Service Information

| Category R | Repair Guidance | Ref. No. R025/13C | Page 1 of 2 |
| Applicable Model 2013 -2014 CX-5 (KE) and 2014 Mazda6(GJ) | | Applicable Countries or Specifications Worldwide | |

Subject: Knocking/Squeaking Noise from Front Strut Bearing

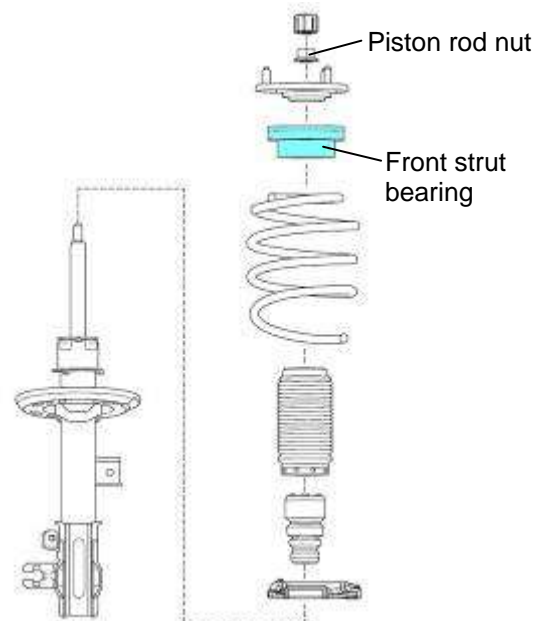
The noise may occur due to the upper housing of the front strut bearing being damaged when applying excessive force to the bearing during customer’s usage.

Material and forming method of the front strut bearing have been changed.

Replace the damaged strut bearing with modified one according to the Workshop Manual.
